**RE** Buildings A1 & A3, National Capital Business Park  
4055 Russell Road, City of Ottawa  
Transportation Impact Assessment Memorandum – 2<sup>nd</sup> Submission

**TO** Wally Dubyk, C.E.T.  
Transportation Project Manager, City of Ottawa

Following the original submission of this Memo (December 2025), Crozier received comments from Wally Dubyk of the City of Ottawa. The original Memo has been revised to address each of the provided City comments in this updated Memo submission. Included in **Appendix A** is a comment response matrix detailing how each of the municipal comments have been addressed.

**04 SITE PLAN**

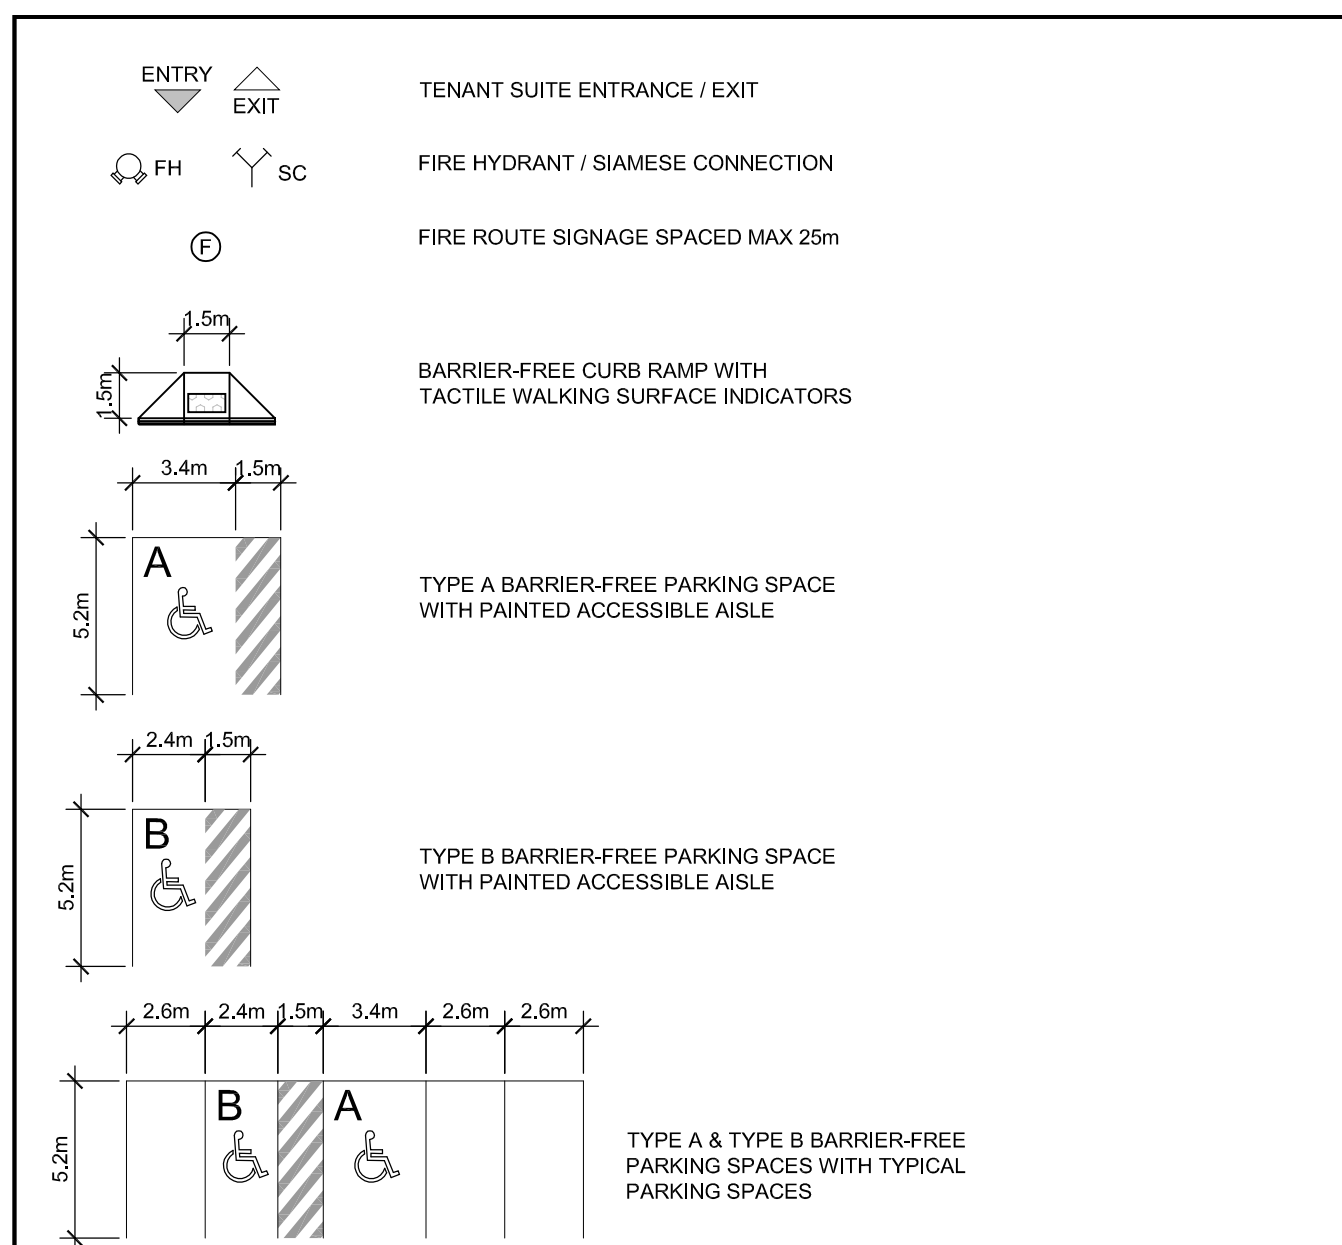
Outstanding	Site Plan	SPA-01 Rev. 05	Mandatory for Approval	Wally Dubyk	Provide pathways and crosswalks from all parking areas to the nearest building entrances to improve safety.	Noted and captured on the latest site plan.
Outstanding	Site Plan	SPA-01 Rev. 05	Mandatory for Approval	Wally Dubyk	To encourage and support the transit trips forecasted, provide a bus pad for bus stop ID 3335 located on Russell Rd along the site frontage. Provide a pathway connection from the bus stop to the closest main building entrance. Alternative locations in consultation with Transit Services for Stop 3335 can be considered should they better align with the site frontage.	Noted. A pad is currently already provided at the intersection of Russell Road and Logistics Private (main access).
Outstanding	Site Plan	SPA-01 Rev. 05	Mandatory for Approval	Wally Dubyk	On Appendix H, outbound trucks appear to encroach on the opposing east-bound traffic lane on Russell Road. Please clarify if this is the case and illustrate what would be required to ensure that trucks do not encroach on opposing lanes. The posted 80km/h speeds and arterial road designation pose a safety concern for overlapping movements on Russell Road.	Noted. This is an existing access and designed to typical TAC standards. Truck encroachment to opposing lanes is common and similar to most of the accesses along the road and in the area. Trucks are expected to wait for sufficient gaps to make the maneuver similar to a left turn that encroaches both lanes.  Further, the site is considering LCV trucks as well. Therefore, truck aprons will ultimately be considered as well to accommodate LCVs.

Project: 4055 RUSSELL ROAD (BUILDING A1&A3)  
 CITY OF OTTAWA  
 Drawing: SITE A1 & A3 EXTERNAL SITE ACCESS  
 AND RUSSELL RD  
 LCV A-TRAIN MANEUVERING

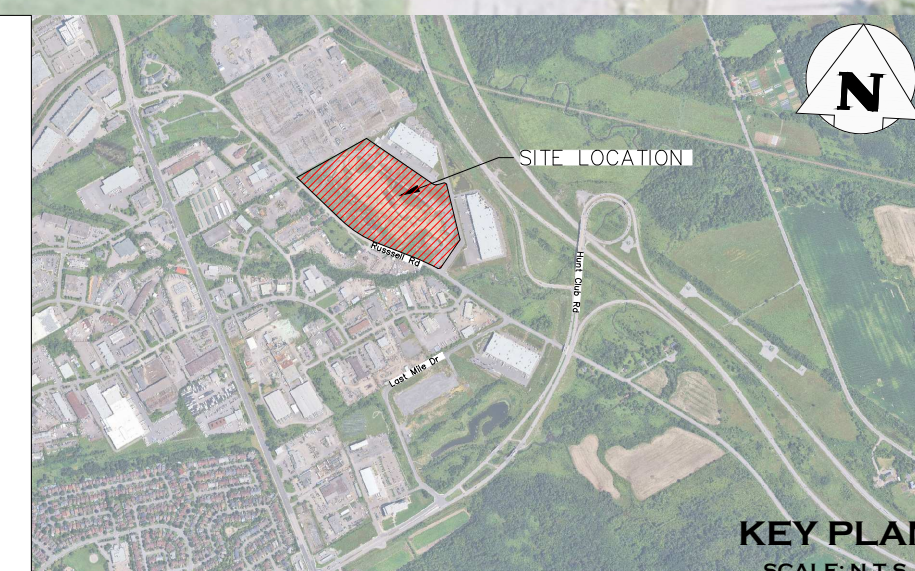
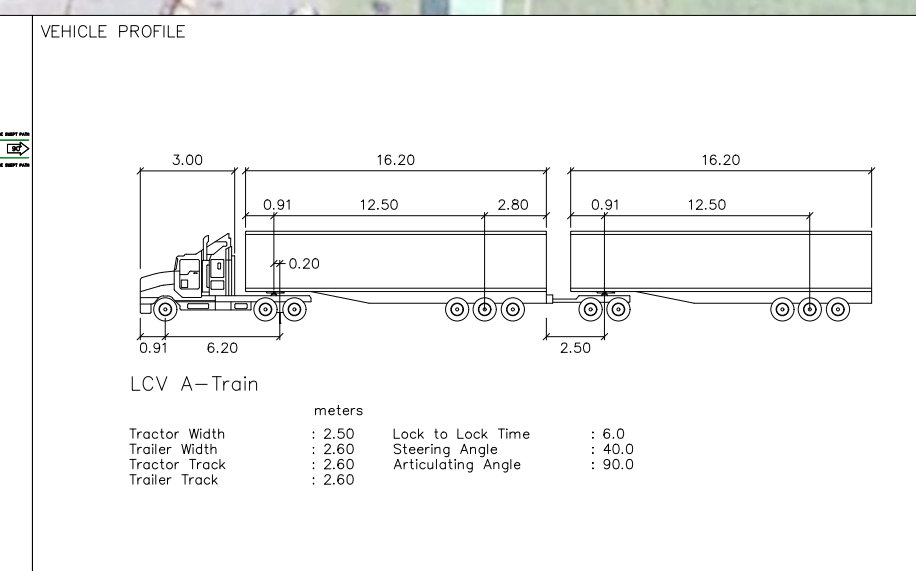
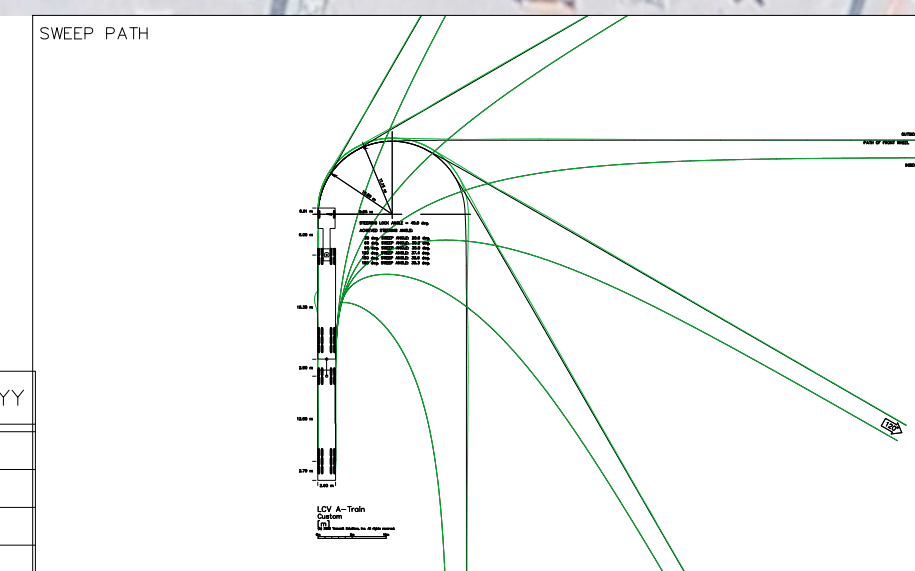
Outstanding	Transportation Impact Assessment	Dated 12/19/25	Mandatory for Approval	Wally Dubyk	Provide turning templates for trucks.	Please refer to the additional swept paths included in Appendix H.
Outstanding	Transportation Impact Assessment	Dated 12/19/25	Mandatory for Approval	Wally Dubyk	Provide elevation of throat length for the accesses per the TAC.	This comment is interpreted to mean evaluating clear throat length of the site accesses. This has been provided in the updated TIA Memo in <b>Section 5.6</b> .
